Broadcom Product Advisory

Taiwan BSMI Code Change

Issue Date: July 1, 2025

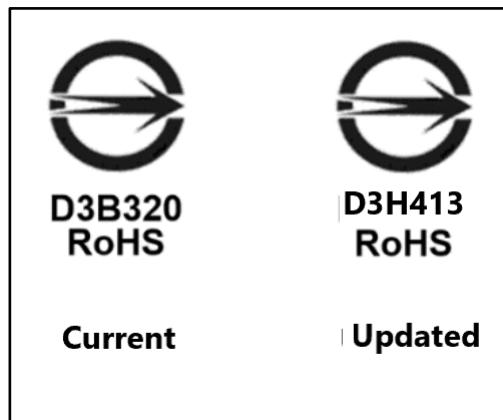
The BSMI code is screen printed on the adapter PCB. Broadcom will temporarily use labels to indicate the new code until the PCB screen printing is updated.

The following picture shows the current and updated BSMI code.
